ADDENDUM NO. 2

For

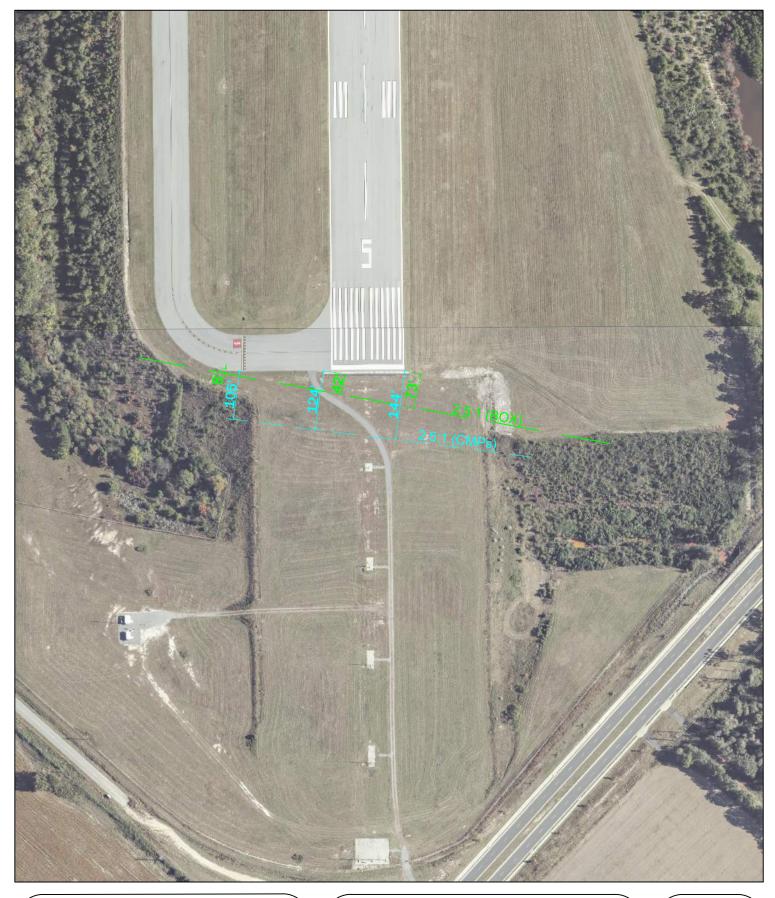
ADDENDUM NO. 2 June 23, 2023

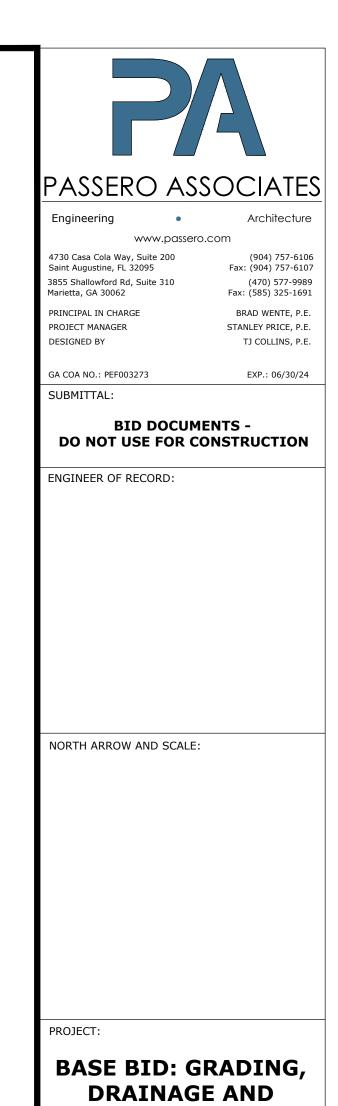
UTILITIES FOR RUNWAY 5 EXTENSION MACON-BIBB COUNTY MIDDLE GEORGIA REGIONAL AIRPORT (MCN) MACON-BIBB COUNTY, GEÓRGIA REVISIONS 6/23/23 SDP ADDENDUM NO. 2 SHEET TITLE: **DRAINAGE DETAILS -**SHEET 2 SHEET: C121 20202946.0003 MAY 2023
